Submittal Package

-51 Sherman St –

Deadwood, South Dakota

WOOD MONUMENTAL SINGLE-HUNG WINDOWS

Historic Spoon Lock

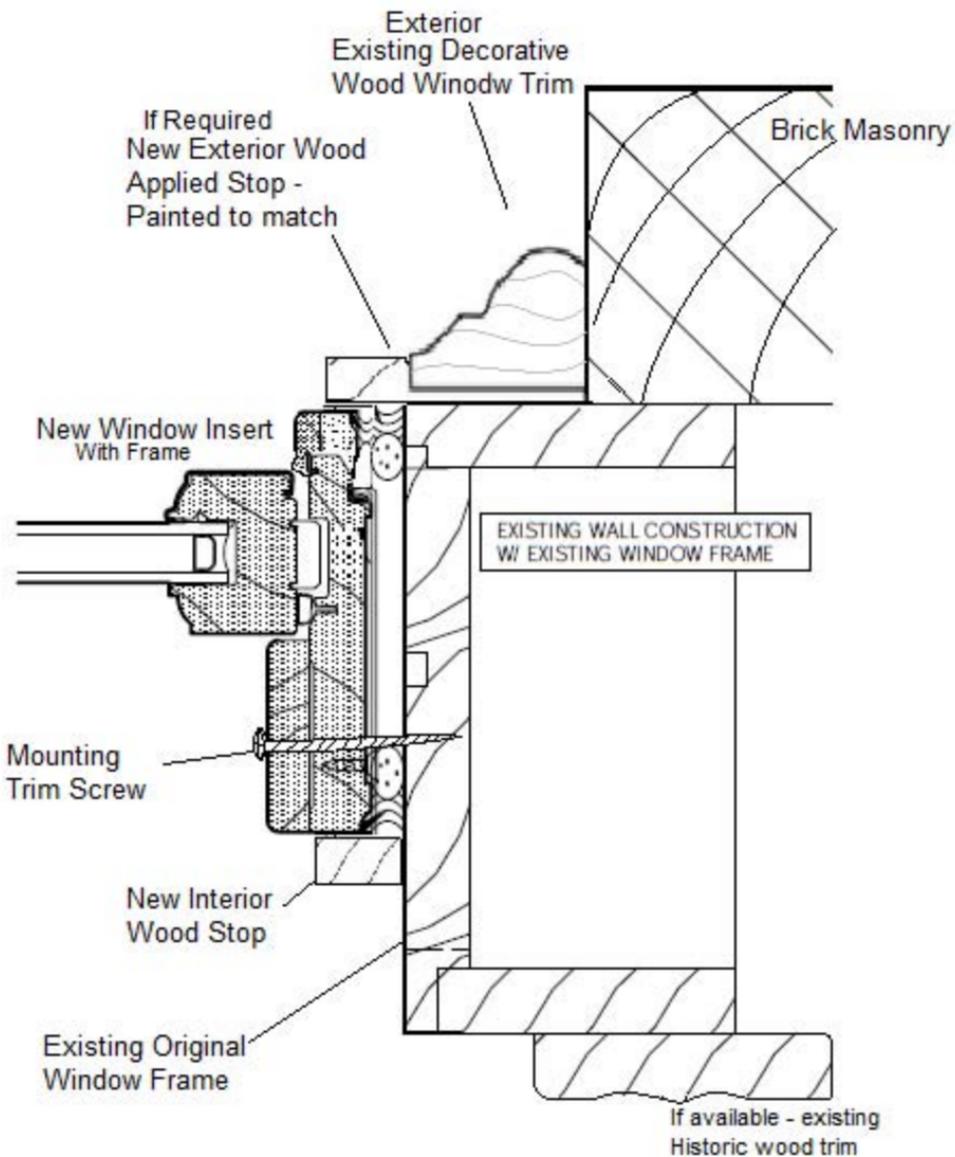
2. [Standard lock (cam-action)] [**Spoon-shaped lock**] [Air-conditioner lock] [Simulated lock]
 3. One installed on sash 37 inches and smaller in frame width, 2 locks installed on sash over 37 inches in frame width.

- D. Lock and Lift Sash Finish: [Baked enamel, [Champagne] [White] [**Brown**] [Matte Black]] **CONFIRM**
- E. **Limited Opening Device: Factory applied device. Nominal 3-3/4" opening concealed from view.**
PLEASE CONFIRM THAT THIS IS NOT "BY PASSABLE"

If Bypassable WOCD (ASTM F2090) is needed each window this is required in will need to be requoted (roughly \$20 add per window.)

Line Number: 90

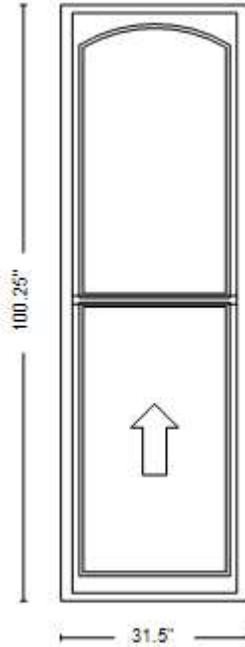
Arched top sash is only present on left 2/3 of rear. square top sash is present on right 1/3 of rear
